RE: Applicant Response to Wetland Consultant Peer Review (WE 286-0297)  
66 Leverett Road, Shutesbury, MA 01072  
Fuss & O'Neill Reference No. 20091032.A22

This letter serves as the Town of Shutesbury's (the Applicant) responses to the Wetland Consultant Peer Review letter provided by Ms. Emily Stockman of Stockman Associates LLC dated November 3, 2022 for 66 Leverett Road, Shutesbury, Massachusetts. This letter also addresses follow-up email correspondence from Ms. Stockman dated November 8, 2022.

Re: Abbreviated Notice of Resource Area Delineation (ANRAD)  
66 Leverett Road  
Shutesbury, MA  
(Parcel ID O-32)  
DEP File # 286-0297  
Wetland Consultant Peer Review

**Photographs 10 and 11** View of IVW 5 vegetation dominated by cranberries (left) compared to upland area (right) dominated by hairy cap moss and some mountain laurel. This upland area, originally included in IVW 4, now separates IVW 4 and IVW 5.

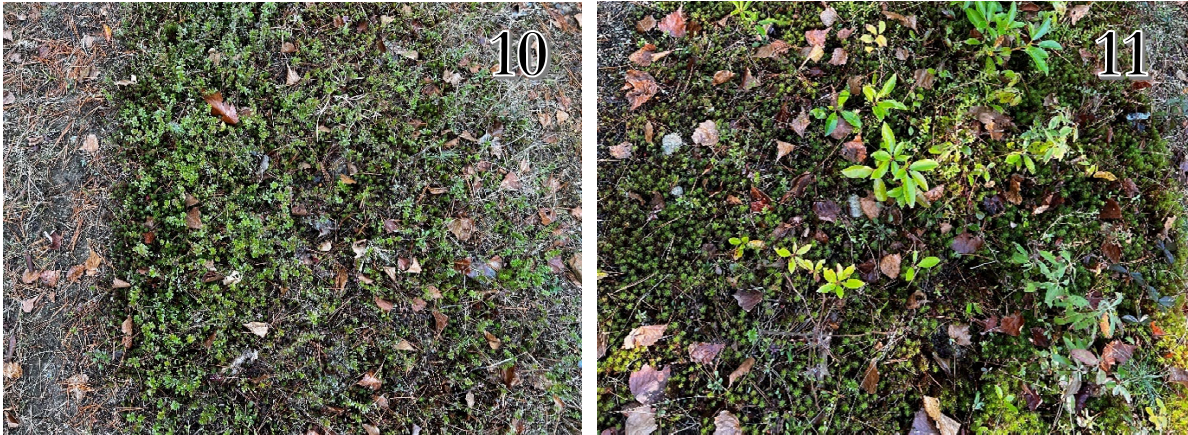
- 7) Overall, Stockman Associates LLC concurs with the boundary of IVW 4 depicted by flags 4A-100 through and including 4A-109. The IVW appears anthropogenic in origin, resultant of historic grading and the establishment of an access way (rutting). It should be noted that based on observed vegetation, the overall IVW boundary encapsulates areas of internal, isolated uplands. A more detailed delineation of that area would likely reduce the overall square footage of the IVW.

**Applicant Response 7: IVW 4 was re-delineated to exclude the upland areas. This re-delineation resulted in splitting IVW 4 into 2 separate wetlands, IVW 4 and IVW 5. Both of these wetlands are less than 1,000 square feet.**

**Figure 2**

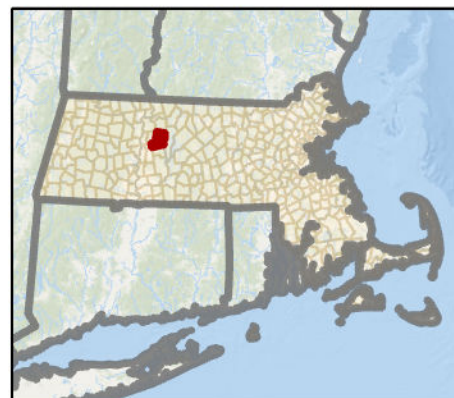
- 4) Subsequent to the original delineation by Fuss & O'Neill, landowner permission was obtained to assess the abutting property to the east (#62 Leverett Road). Based on an observed wetland plant community, hydric soils, and hydrologic connections, IVW 2 depicted on the ANRAD Figure 2 and 3 is a Bordering Vegetated Wetland. The delineated wetland system continues to the east within the abutting property and borders on a drop inlet connected to an open water BVW (small, anthropogenic depression/impoundment). The open water BVW within #62 Leverett Road is connected to an intermittent stream and additional BVW to the east via an overflow outlet pipe and culvert.

- a. Stockman Associates LLC recommends that the westerly boundary of IVW (BVW) 2 (proximal to the access way, dump piles, and the wood line) be revisited.

**Applicant Response 4: IVW 2 has been updated to BVW 2. Refer to Figures 2 and 3 for updated maps.**

**Applicant Response 6a: The westerly boundary of BVW 2 was revisited and the boundary extended to the west approximately by 12 feet. Refer to the Wetland Site Investigation Memo (*Attachment B*) and updated Figures (*Attachment C*) for reference.**

**The updated ANRAD will include approval of BVW and IVW boundaries, and the 100-foot Buffer Zone. The 100-foot Buffer Zone is shown within the ANRAD Review Area from delineated wetland resource areas within the subject parcel and from MassDEP mapped wetlands (see Figures 2 and 3). For wetland resource areas located outside of the subject parcel, the 100-foot Buffer Zone is shown from the DEP-mapped wetlands. DEP-mapped wetlands are only shown outside of the ANRAD Review Area in Figures 2 and 3 since these areas were not delineated in the field.**

**Figure 3-1**

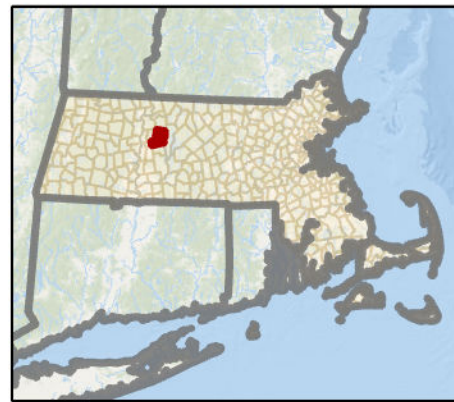
- 3) Stockman Associates LLC concurs with the boundary of BVW 3 depicted by flags 3A-100 through and include 3A-118 and 3B-100 through and including 3B-133 with the exception of the boundary along flags 3A-114 and 3A-115. This portion of the boundary appears to have been altered by historic fill and dumping (observed buried debris, surface litter and breakout fill).

Stockman Associates LLC recommends that the BVW boundary along flags 3A-114 and 3A-115 be revisited using the criteria presented in “Section 5 Difficult Situations” of the Regional Supplement to the Corps of Engineers Wetland Delineation Manual: Northcentral and Northeast Region, ed. J. S. Wakeley, R. W. Lichvar, and C. V. Noble.

**Applicant Response 3: The Applicant will update the ANRAD to exclude the boundary between 3A-114 and 3A-115. The Town of Shutesbury is in the process of defining a restoration plan for BVW 3. The Applicant is respectfully requesting to allow the assessment of the BVW boundary between 3A-114 and 3A-115 to occur during restoration efforts. The updated Figure 2 and 3-1 excludes the boundary between these flags.**
